APPLICATION NO.	FILING DATE	FIRST NAMED INVENTOR	ATTORNEY DOCKET NO.	CONFIRMATION NO.
10/824,827	04/15/2004	Claude Ray		7739
33376	7590	04/04/2006		
KENNETH L. TOLAR 2908 Hessmer Avenue Metairie, LA 70002			EXAMINER REESE, DAVID C	
			ART UNIT	PAPER NUMBER
			3677

Office Action Summary	Application No.	Applicant(s)	
	10/824,827	RAY ET AL.	
	Examiner	Art Unit	
	David C. Reese	3677

DETAILED ACTION

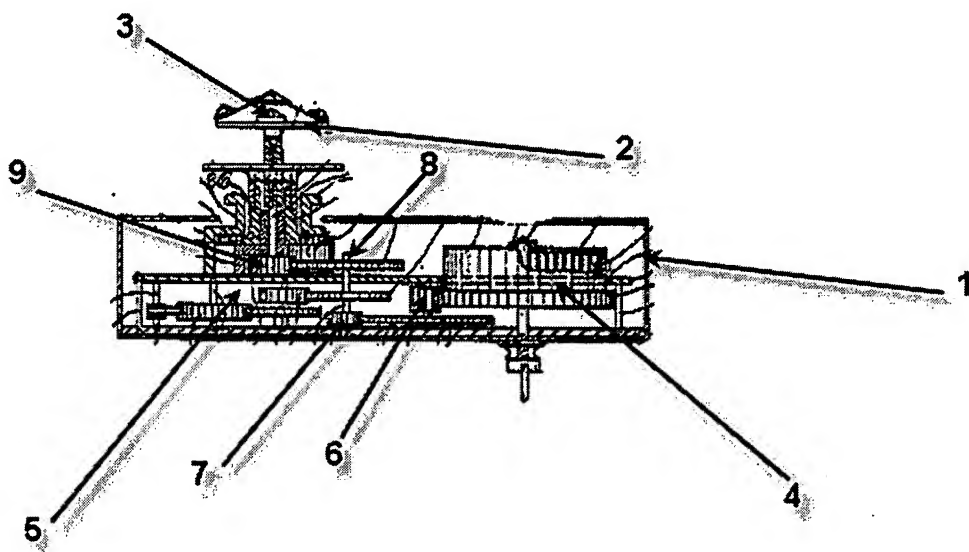
[7] Claim 11 is rejected under 35 U.S.C. 102(b) as clearly anticipated by Blume, US-1,025,447, because the invention was patented or described in a printed publication in this or a foreign country, or in public use or on sale in this country more than one (1) year prior to the application for patent in the United States.

As for Claim 11, Blume teaches of a jewelry item with a rotating gemstone (see figure below) comprising:

a substantially hollow housing (1) having an upper end and a lower end;

a bezel (2) rotatably mounted on the upper end of said housing;

a gemstone (3) mounted on said bezel (2);

a motor means (4) received within said housing (1) for automatically rotating said bezel and said gemstone (3) at a predetermined, discrete speed (after the winding of the spring, the motor then actuates the gears at a predetermined, discrete speed);

a gear assembly (5) including a plurality of gears (6-9) driven by said motor means (4) and operably connected to said bezel (2), said gears (6-9) having a predetermined, precise gear ratio for rotating said bezel at a discrete speed, wherein said gear assembly (5) further includes a drive gear (6) connected to said means (4); and an intermediate gear (7) engaging said drive gear (6), said intermediate gear (7) having an upper surface with a sprocket (8) extending therefrom, and a bezel gear (9) connected to said bezel (2) and engaging said sprocket (8).
